## Use of the 10-Pin-to-14-Pin Adapter Harness

### Models Affected

Clamp

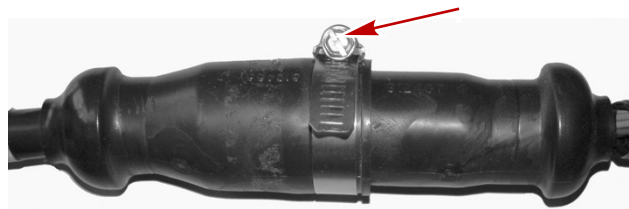
MerCruiser introduced the 14-pin twist-lock harness connection to engines in the affected serial number ranges and made available an adapter harness (part number 84-866337T01). This adapter connects a boat with the older-style molded rubber 10-pin connector to a new engine with a 14-pin connector. In some installations, this harness has failed because it was installed without the recommended screw-type hose clamp.

Inspect the adapter harness when servicing one of these engines. If a clamp is not present, install a clamp on the 10-pin connector and tighten it securely. Do not overtighten or deform the connector. Please also ensure that the connection is not oriented at an angle or installed in a location that places the connection at risk for exposure to moisture.

Use clamps or cable ties to secure the harness so that the connector slopes downward a minimum of 30° from horizontal to provide additional protection from water intrusion. Verify that the location does not interfere with moving parts on the engine or boat. To facilitate installation, apply soapy water to the outside of the 10-pin connection. Ensure that no water becomes trapped inside the connector during installation. Do not use a petroleum lubricant on the rubber connector, because it often allows the connection to separate during operation.

A 20–40 mm (0.8–1.6 in.) hose clamp (if needed), part number 54-815504220.
